# **OAKLAND CITY CENTER PROJECT**

## *Final Environmental Impact Report*

*ER 99-15  
SCH No. 99081119*

**Seismic Hazards Mapping Act of 1990**

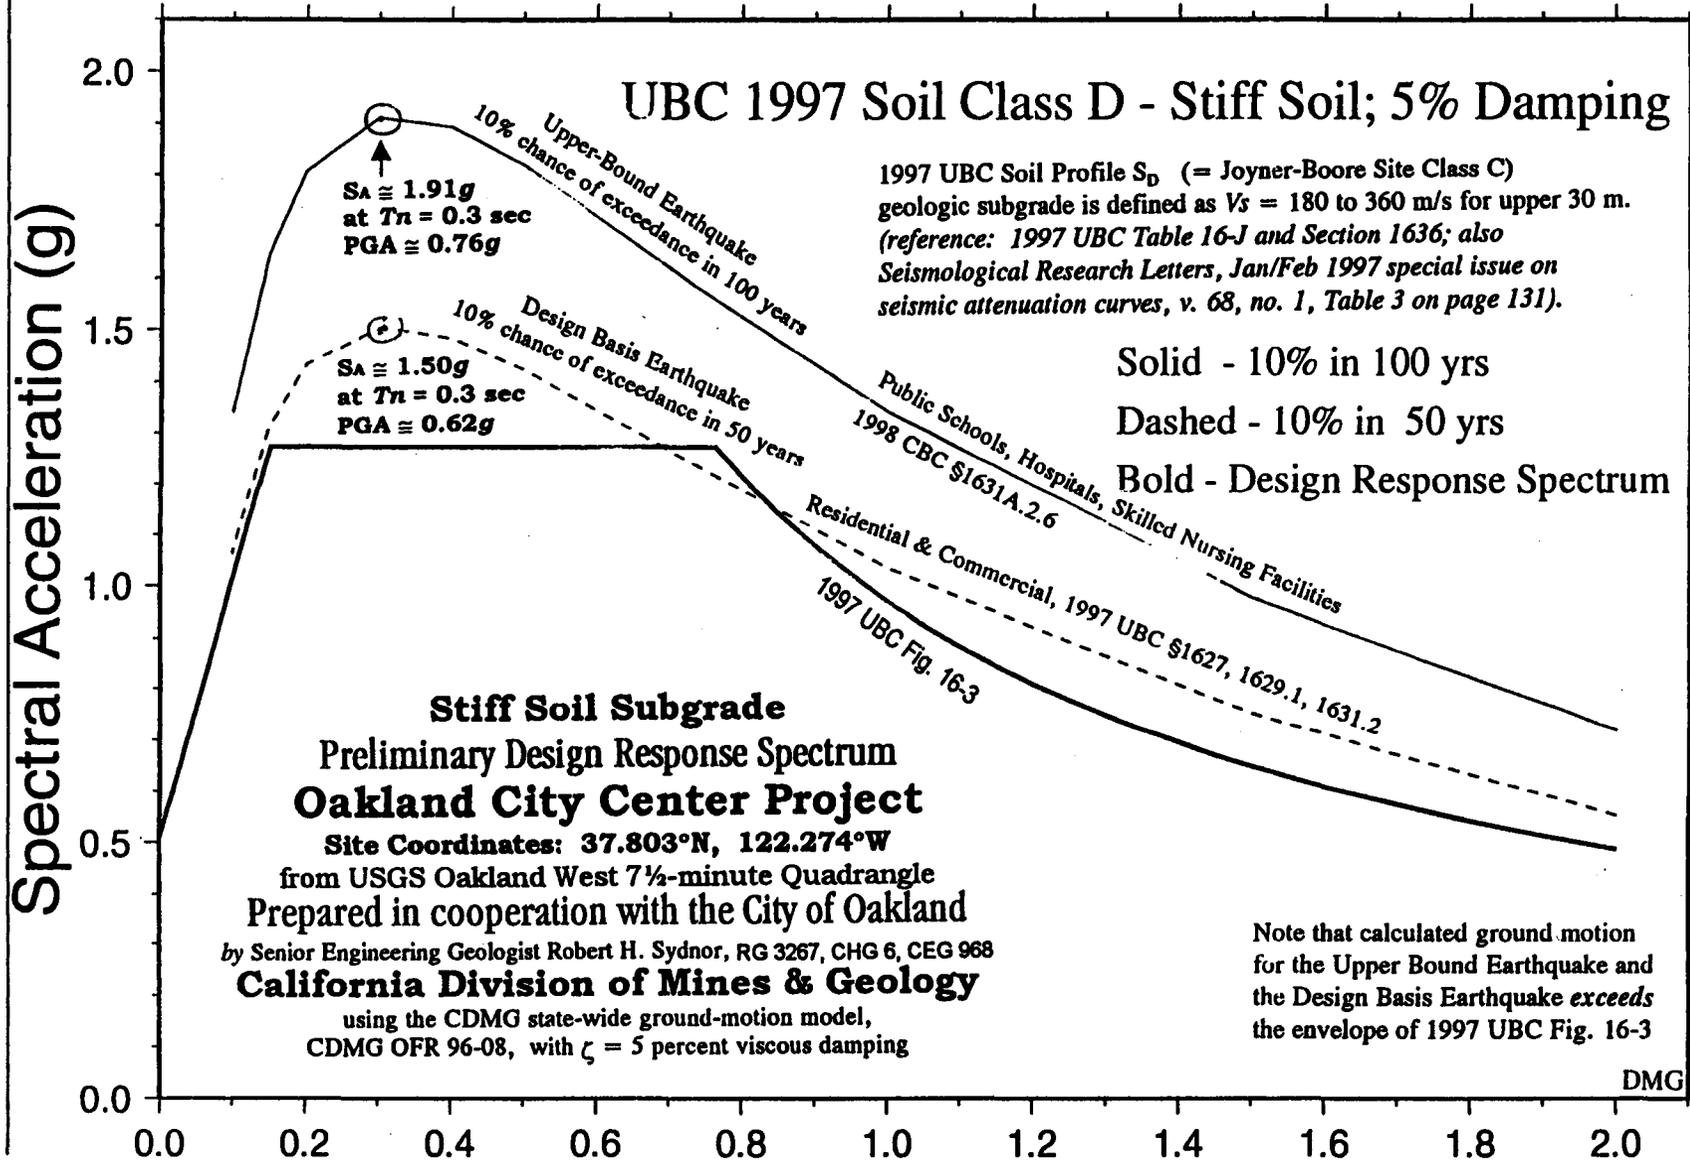
implications for the high-rise buildings proposed. We recommend that the ground motion impacts of this project also be evaluated in the final EIR.

In summary, we recommend that a complete engineering geology and seismology report by a consulting Certified Engineering Geologist and Registered Geotechnical Engineer be conducted. The results of this study, including recommended mitigation measures, should be incorporated in the final EIR.

**B-1)** Geology and soils are discussed in the project Initial Study (DEIR Appendix A), pp. 8-10, where it is noted that the project sites are located in an area “which may experience a variety of types of ground failure due to ground motion, particularly if there is strong seismic activity.” As also stated on p. 8 of the Initial Study, “the applicant shall be required to submit an engineering analysis along with detailed engineering drawings to the Building Services Division [of the Oakland Community and Economic Development Agency] prior to excavation, grading, or construction activities on the site, consistent with standard City practices, to ensure that all buildings are designed and built in conformance with the seismic requirements of the City of Oakland Building Code.” This review would ensure that necessary engineering and design features are included in the project to reduce potential damage to structures from ground shaking or seismic-related ground failure, including liquefaction. Therefore, potential damage to structures from geologic hazards on the project site would be ameliorated through the Building Services Division requirement for a site-specific geotechnical report and review of the building permit application, and implementation of the project would not result in a significant impact related to geological or seismic hazards. Because of the Building Service Division requirements, it is not necessary for the geotechnical report to be analyzed in the EIR.

The map noted by the commenter was officially released in final form on March 29, 2000, and can be viewed at the California Division of Mines and Geology web site ([www.consrv.ca.gov/dmg/index.htm](http://www.consrv.ca.gov/dmg/index.htm)). Like the preliminary map provided by the commenter, the official map shows the project site to be about one block outside an area of potential liquefaction. According to the project sponsor’s geotechnical consultant, soils beneath the project site consist of dense Merritt sand and are not susceptible to liquefaction.<sup>2</sup>
